**LEESBURG BOARD OF ARCHITECTURAL REVIEW
STAFF REPORT**

**WORK SESSION: 5 NOVEMBER 2012
AGENDA ITEM 6a**

BAR Case No. TLZM-2012-0005: New construction of a service station, convenience store and car wash in a planned development.

Reviewer: Kim K. Del Rance, LEED AP
Address: Land Bay C, Trimble Plaza and Miller Drive
Zoning: PEC, H-2 Overlay District
Referral Request: Irish Grandfield, Environmental Planner
Owner Representative: Christine Gleckner, AICP, Walsh, Colucci, Lubely, Emrich & Walsh PC

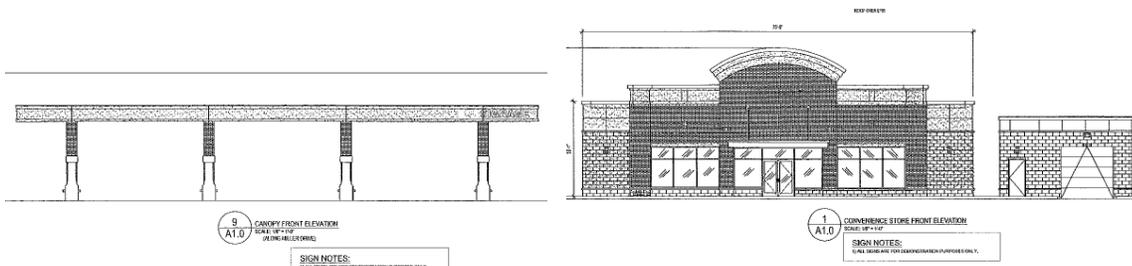
Façade appears to be pasted on front and can be seen easily from rear as not being functional

As can be seen by drawings of façade and gas pump canopies above, the façade will rise above the height of the canopies which will block its visibility and change the scale of the building in relation to the canopies which are already being requested to be higher than is normally allowed due to the slope of the site.

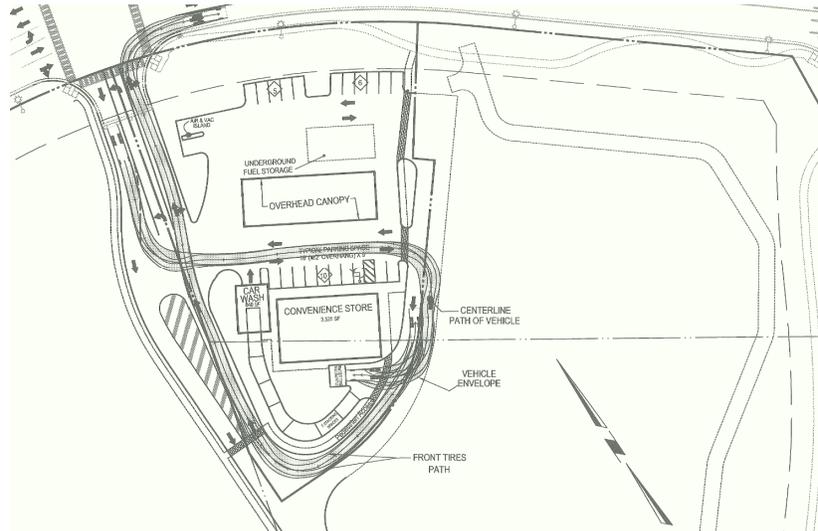
- ◆ Parking for this site is exclusively at the front of the site, which **is not to be done**.

A1.0

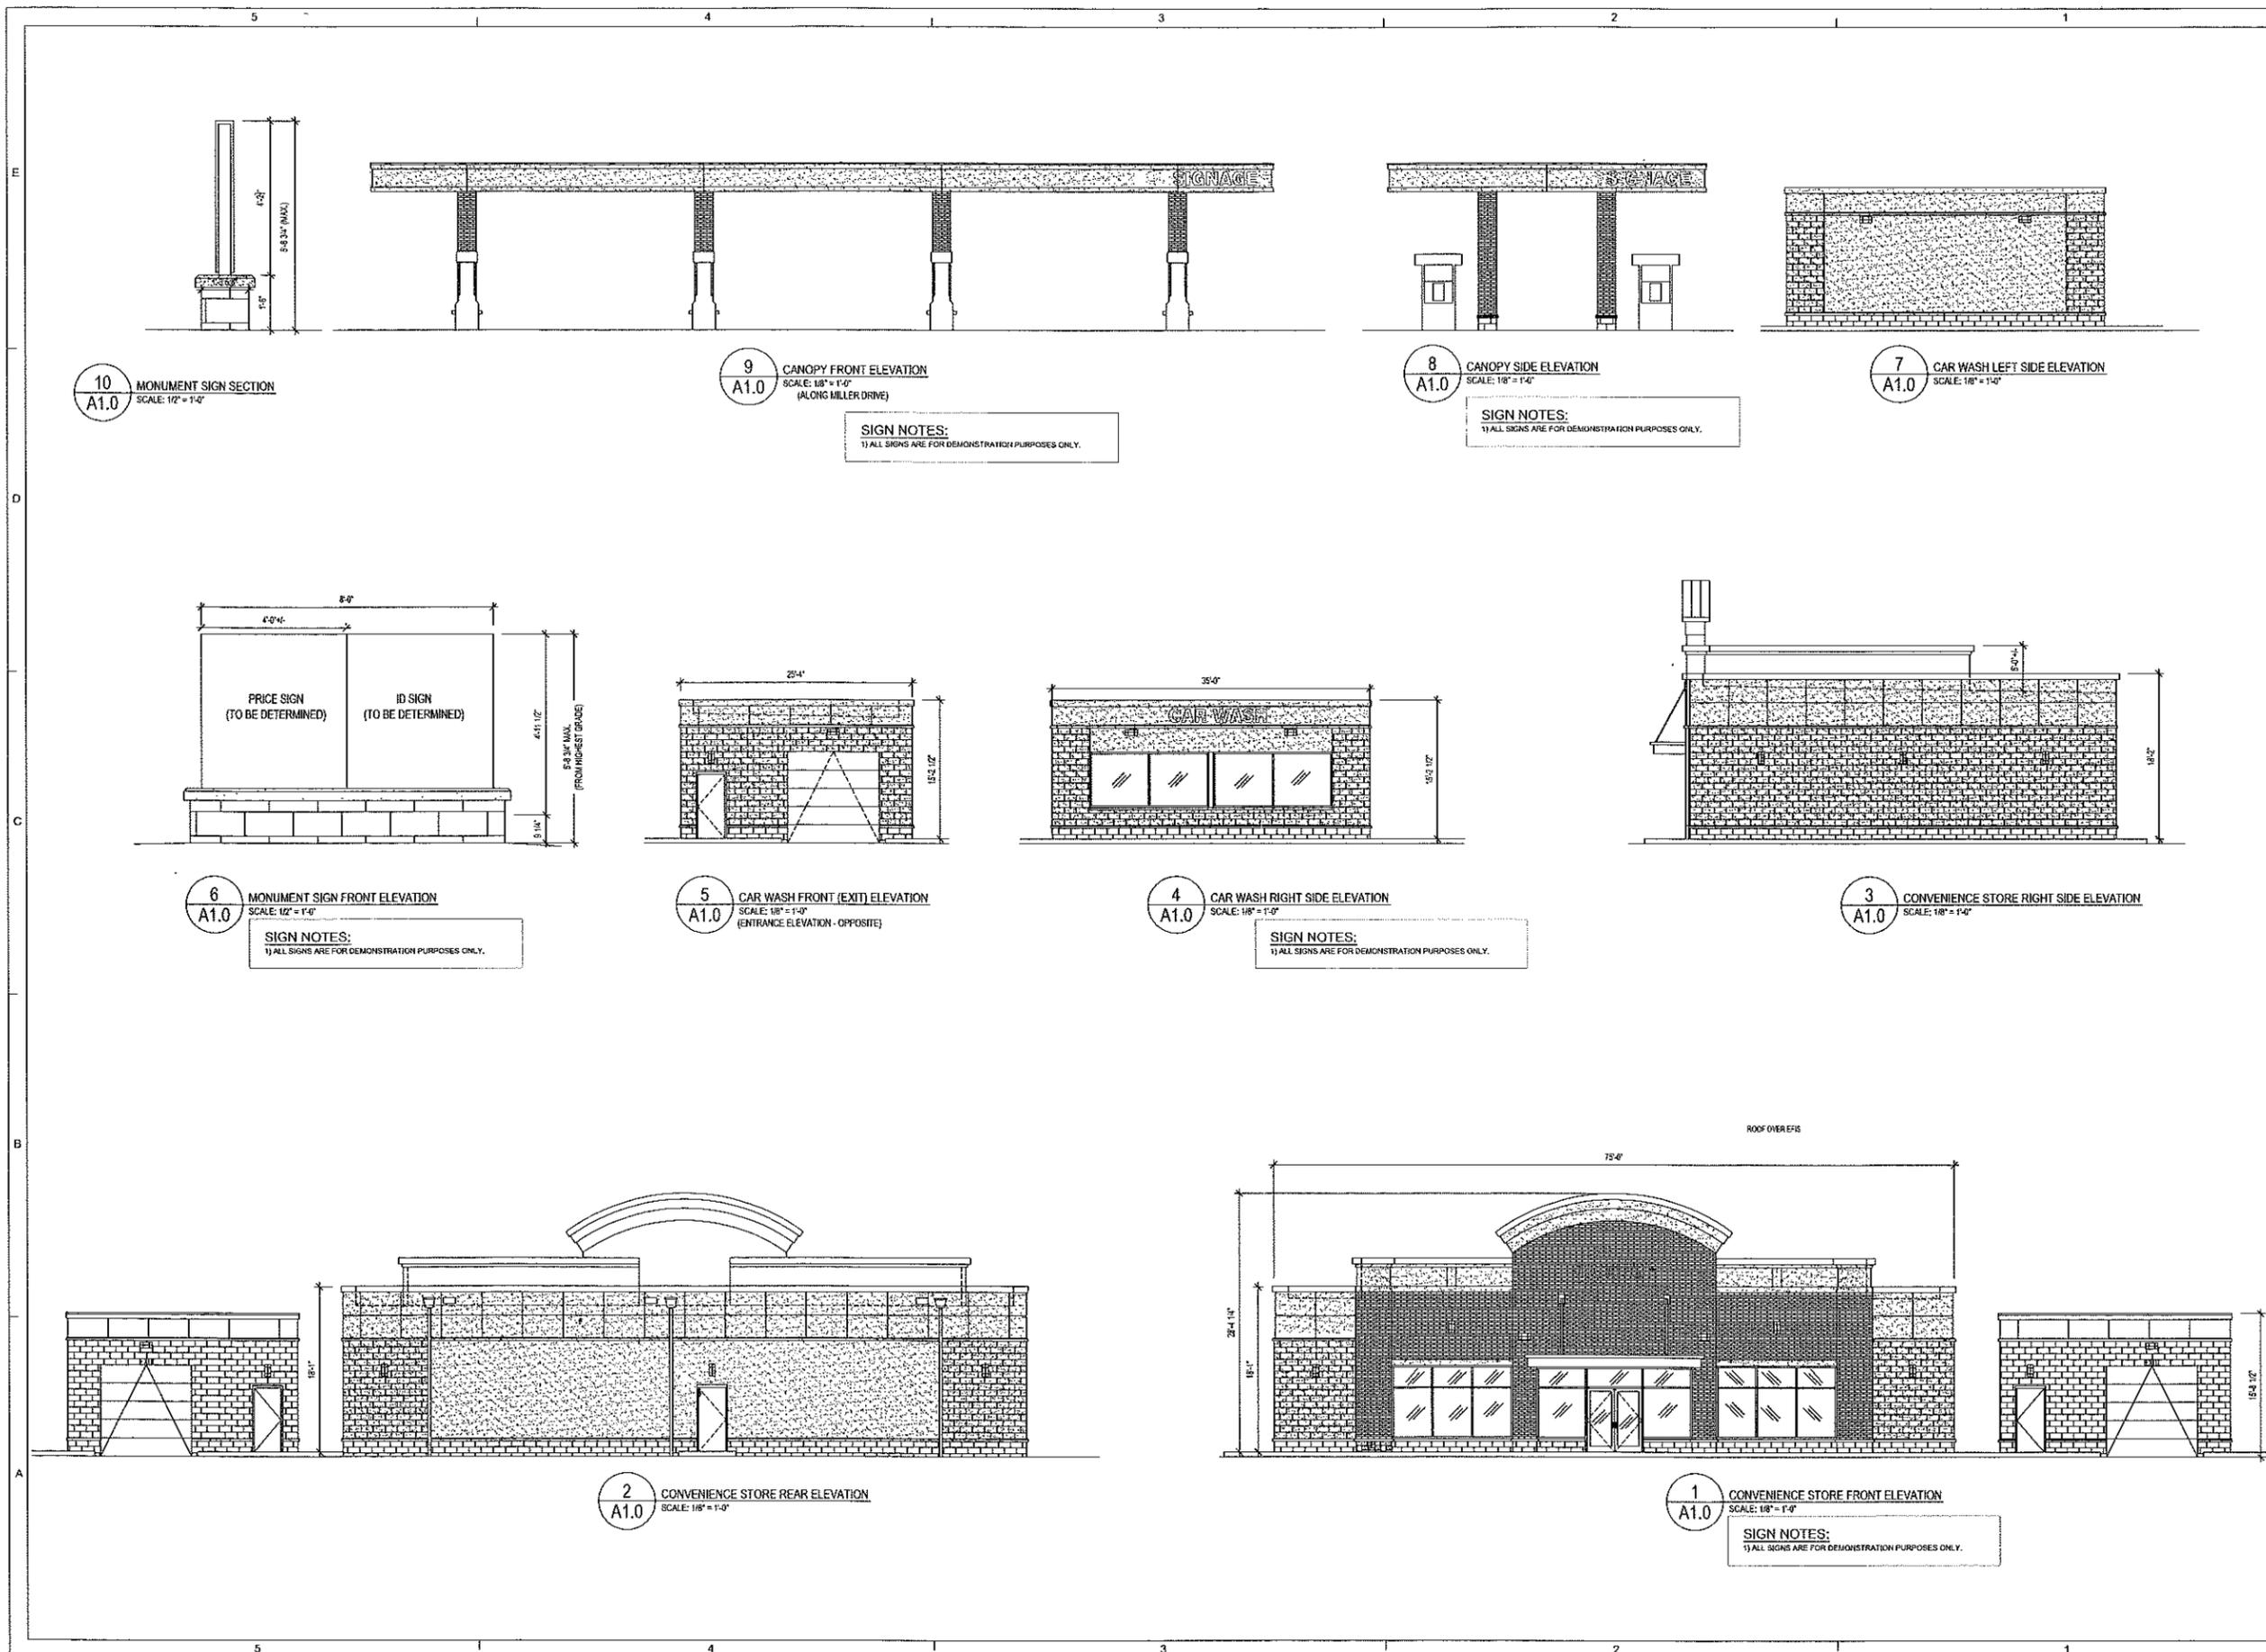
The blank walls should be detailed to a human scale or screened.

The smooth stucco on the rear and side should be detailed to a human scale or have the materials altered.

The roofs should be compatible with the existing approved roofs in this development, all of which are gabled with shingles.
